Economic Commission for Europe**Administrative Committee for the TIR Convention, 1975****Technical Implementation Body****Fourth session**

eTIR conceptual, functional and technical specifications:**Version 4.4****Concrete amendment proposals*****Note by the secretariat****I. Background and mandate**

Figure I
Current customs management of guarantees class diagram

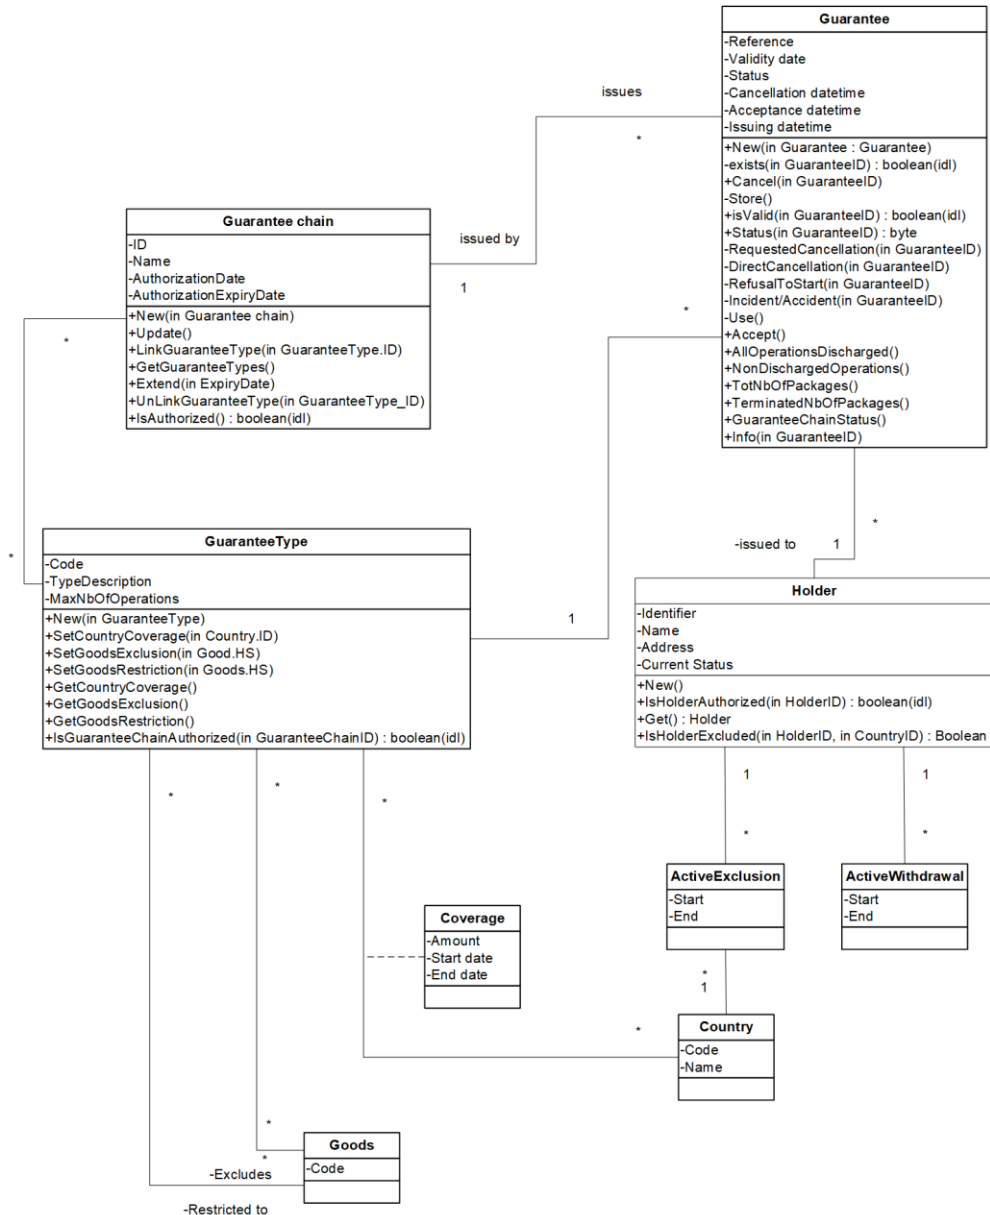
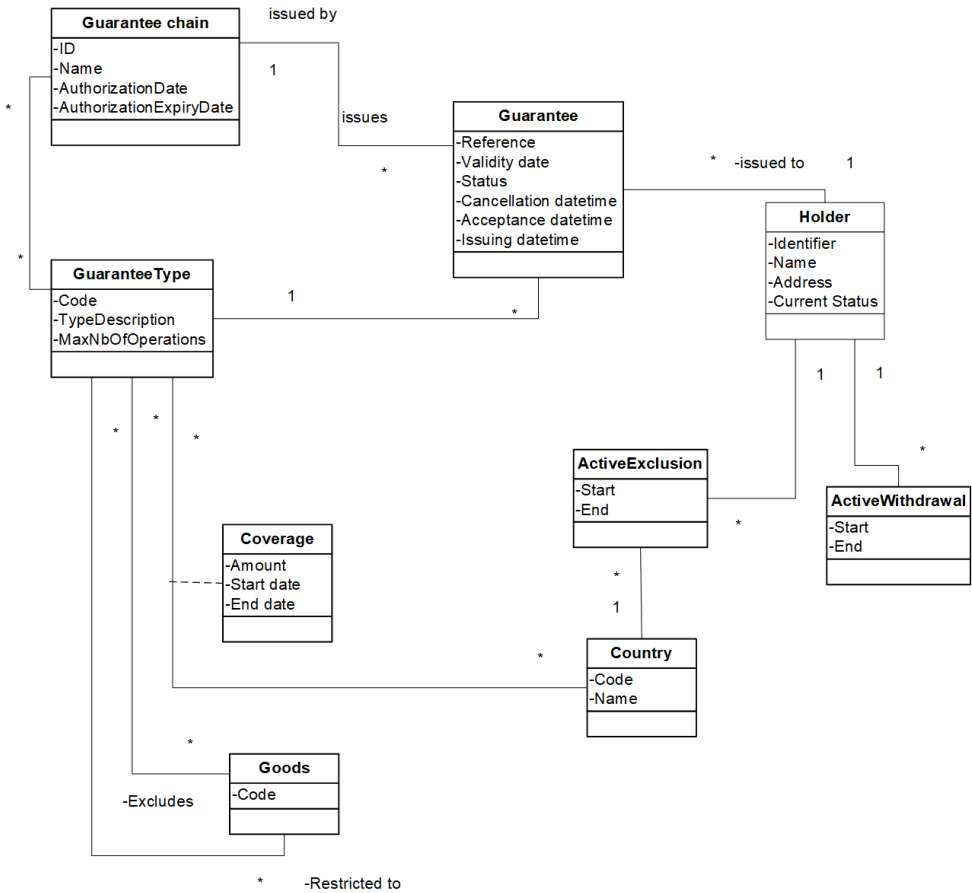
23. UML Class diagrams used in version 4.3 of the eTIR functional specifications contain not only classes, their relationships and their attributes, but also a set of methods that were aimed at facilitating the development of the eTIR international system. As such, these methods have little to no use for the countries that wish to amend their customs system to implement the eTIR procedure. Figures I and II below show the difference between the current and the simplified version of the customs management of guarantees class diagram (Figure 1.19 of the eTIR functional specifications).

24. At its third session, TIB agreed to simplify the class diagrams.

Figure III
 UML activity diagram for the Start TIR operation process

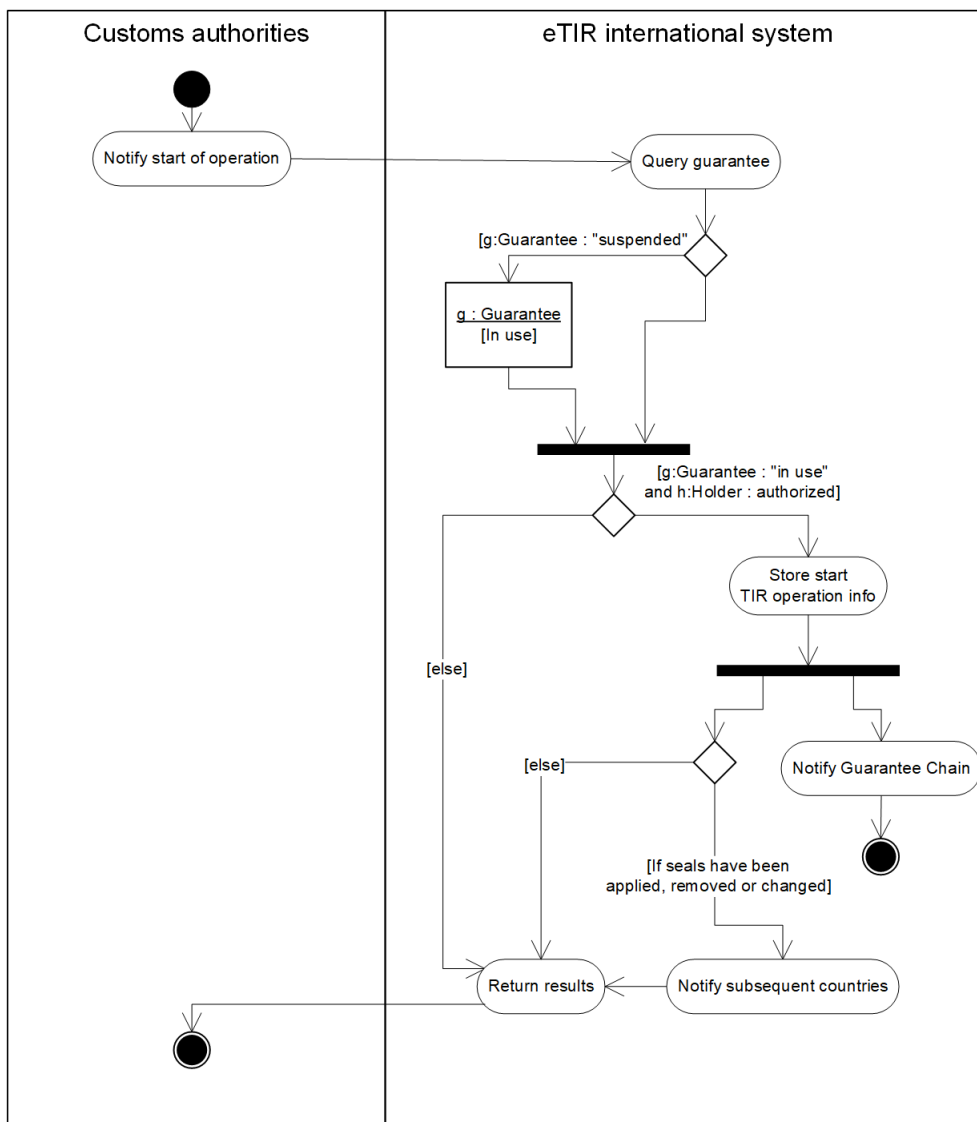
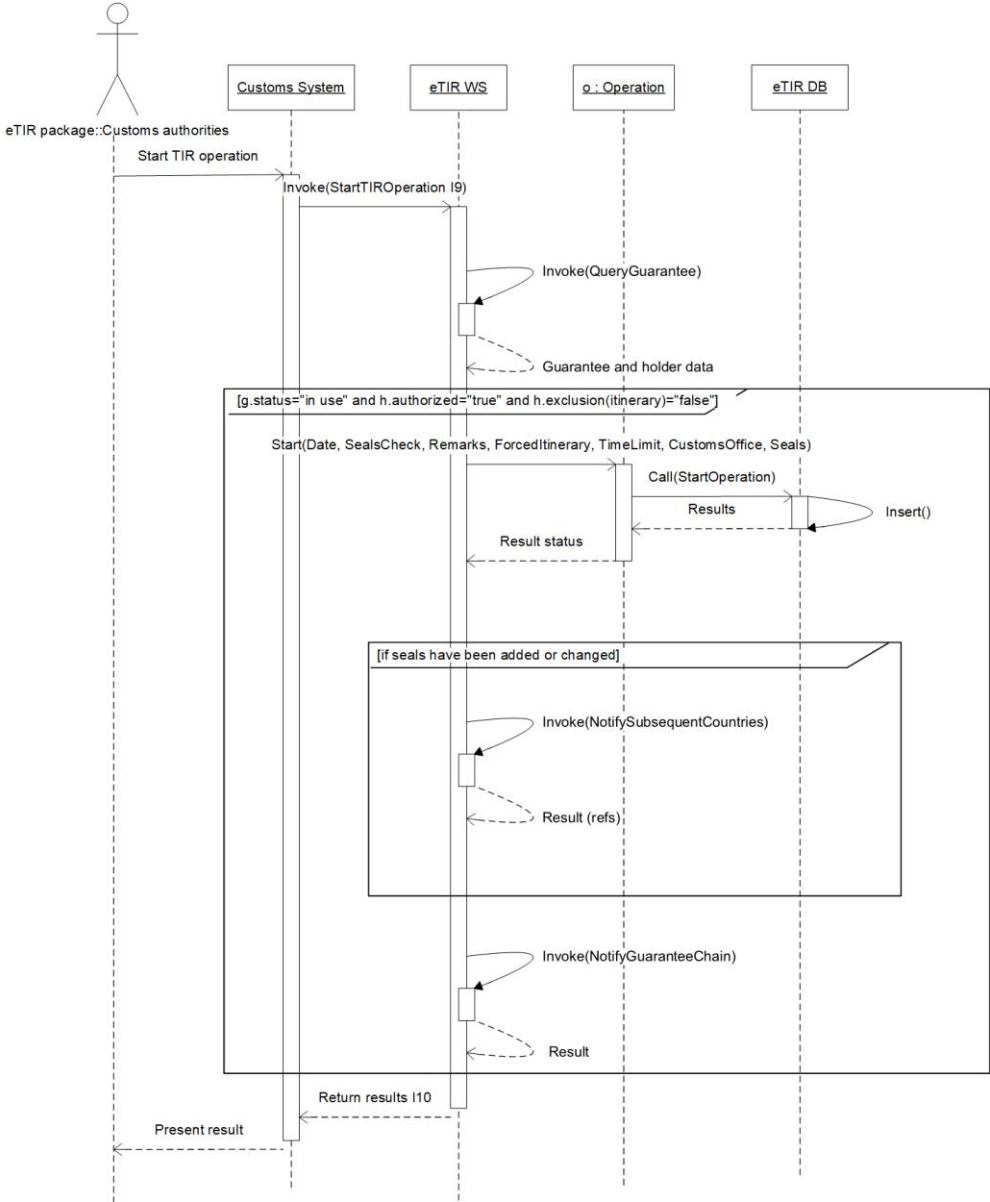
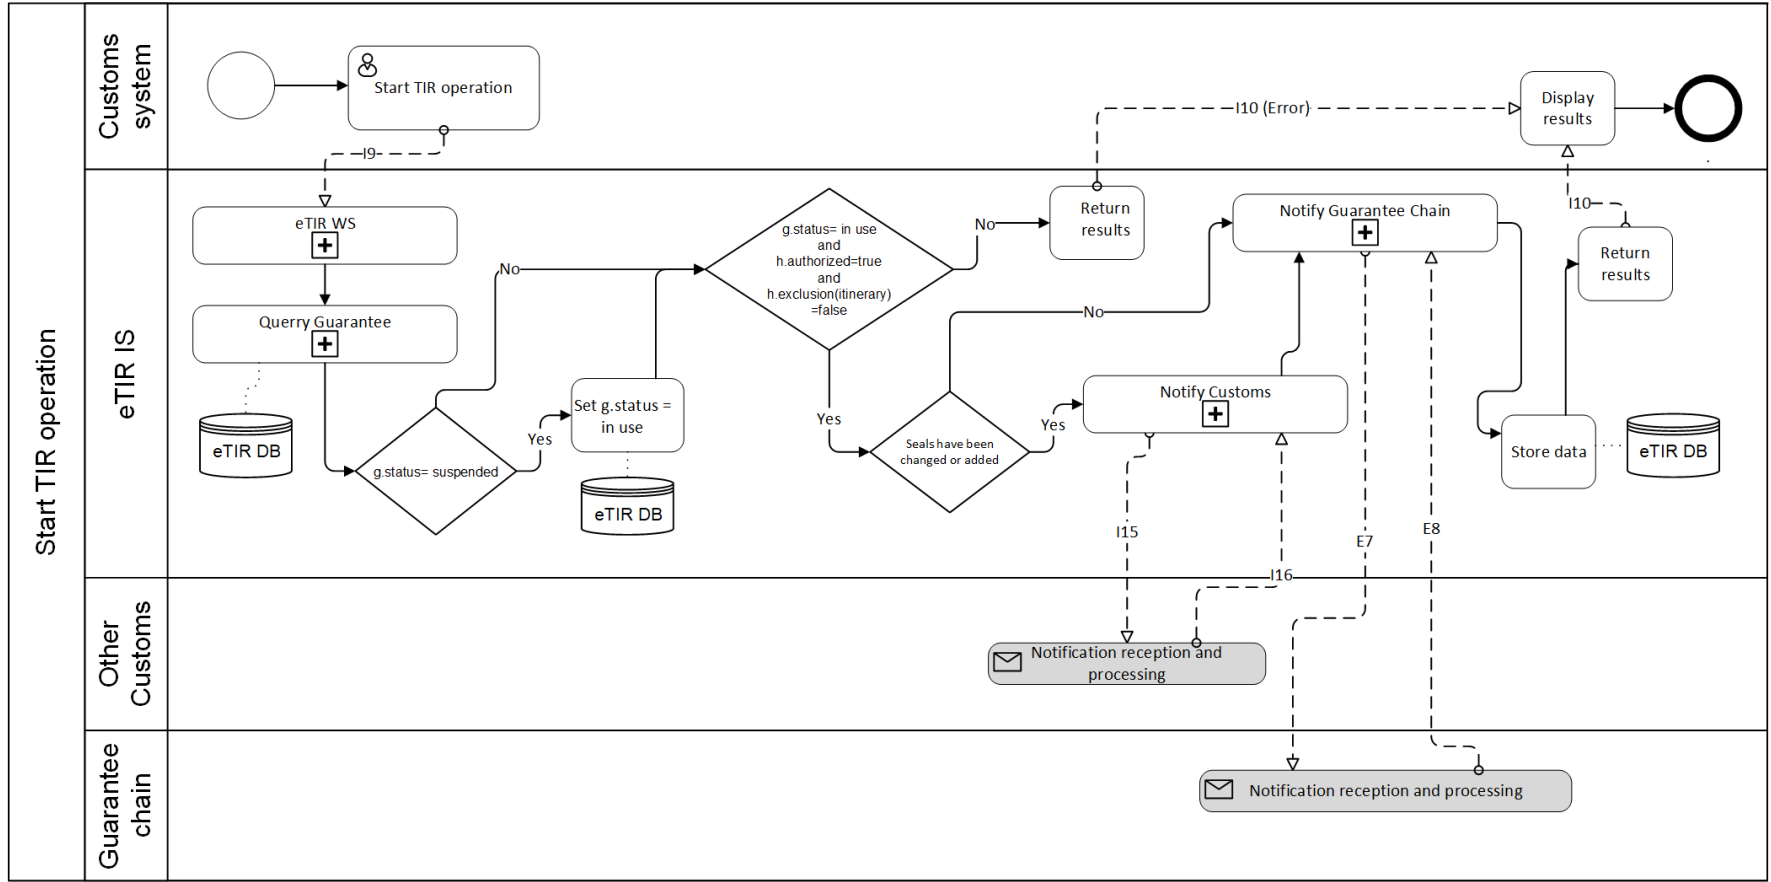
25. In version 4.3 of the eTIR specifications, in line with the Unified Modelling Methodology (UML) chosen originally for the eTIR project, the modelling of processes is done using UML activity and sequence diagrams. In recent years, the business process model and notation (BPMN) has gained in popularity in both the business and Information and Communication Technologies (ICT) communities and is, therefore, better understood by laymen and experts alike. With that in mind, TIB might wish to consider if, in version 4.4 of the eTIR specifications, BPMN should replace the activity and sequence diagrams used in version 4.3. Figures III, IV and V below show the UML activity diagram (Figure 12 of the eTIR concepts), UML sequence diagram (Figure 1.9 of the eTIR functional specifications) and the Business Process Diagram for the Start TIR operation process.

26. At its third session, TIB agreed to replace the existing diagrams (in Unified Modelling Methodology – UML) in the conceptual and functional specifications with the newly proposed diagrams (in Business Process Model and Notation – BPMN), in line with the examples above.
